REVISED RESPONSE TO REQUEST FOR ADDITIONAL INFORMATION**APR1400 Design Certification****Korea Electric Power Corporation / Korea Hydro & Nuclear Power Co., LTD****Docket No. 52-046**

RAI No.: 167-8191

SRP Section: 09.01.01 - Criticality Safety of Fresh and Spent Fuel Storage and Handling

Question No. 09.01.01-4

Figure 3.7.16-1 (page 1 of 1)
Discharge Burnup vs. Initial Enrichment for Region II Racks

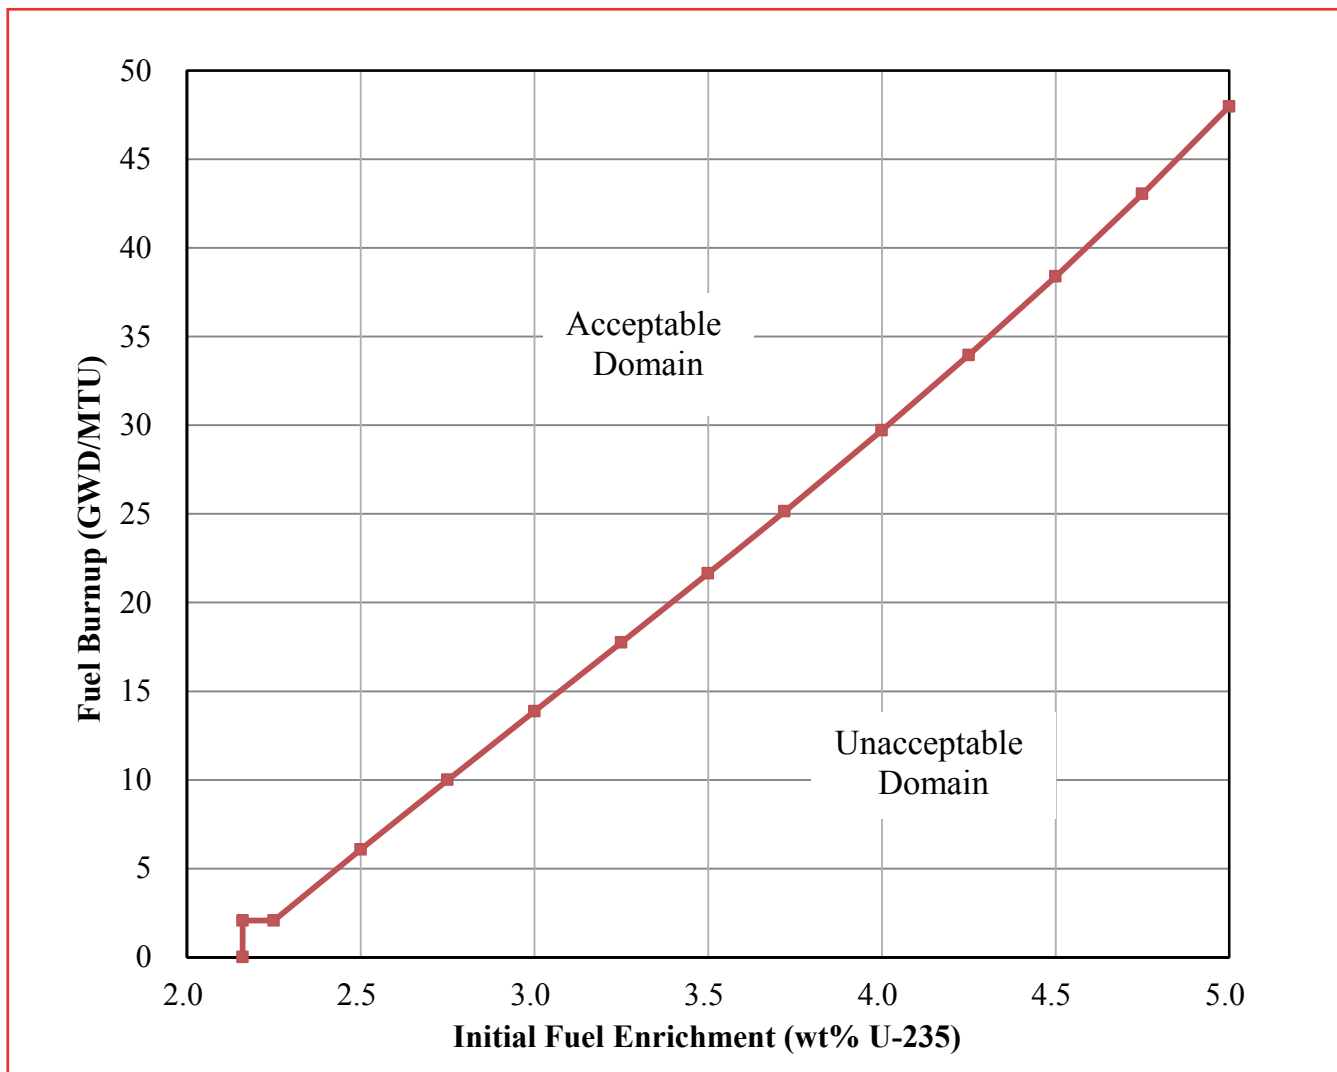
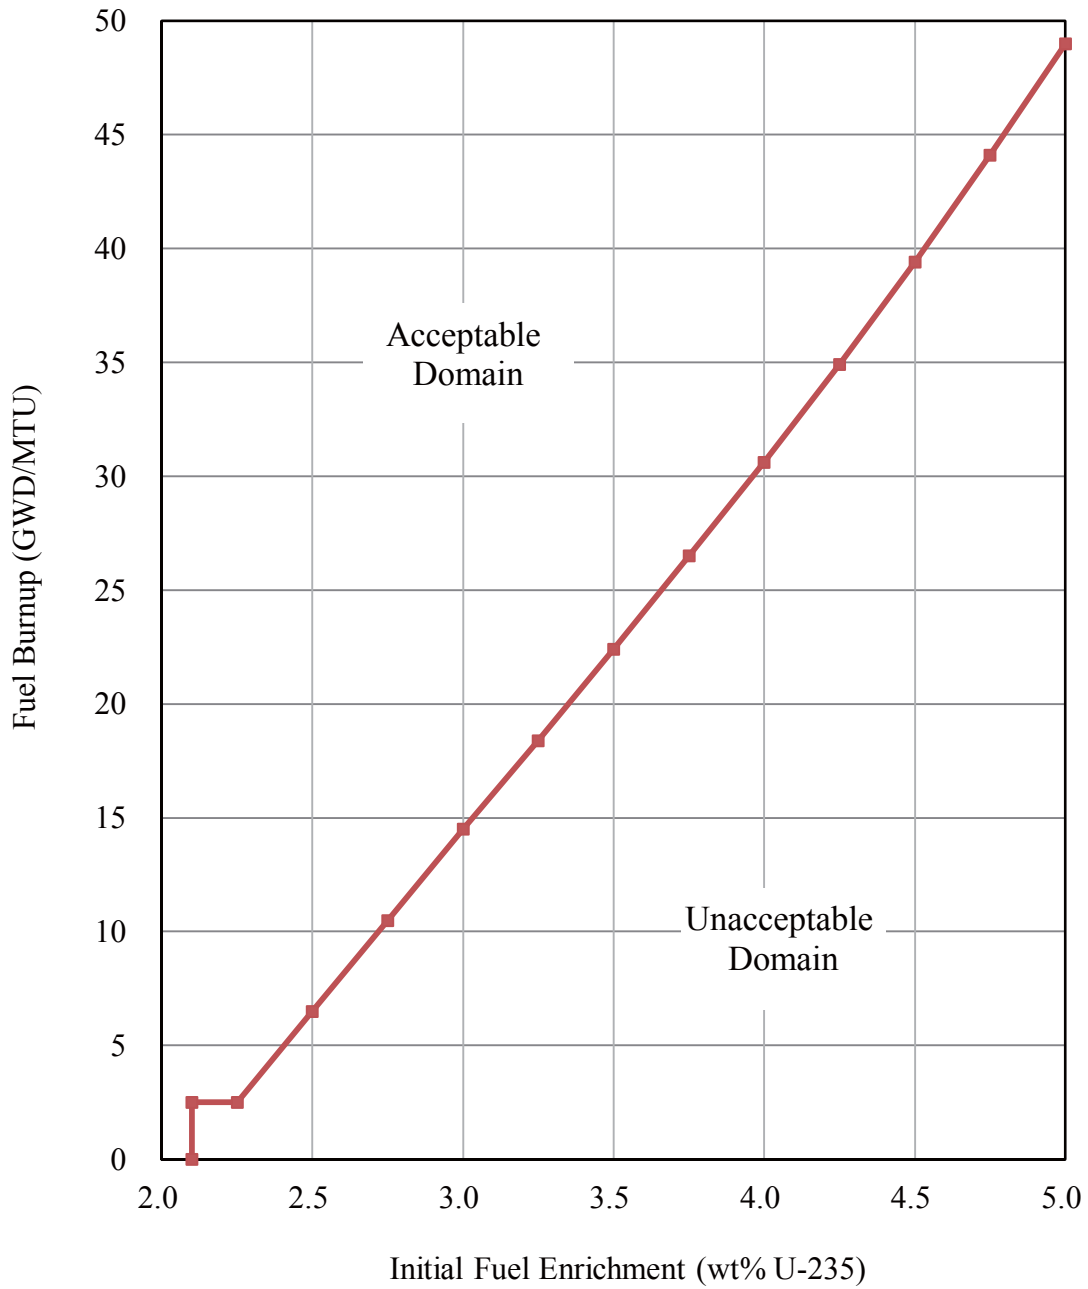
This figure should be replaced with the figure in the next page.

Figure 3.7.16-1 of technical specifications will be revised as indicated in Attachment 2.
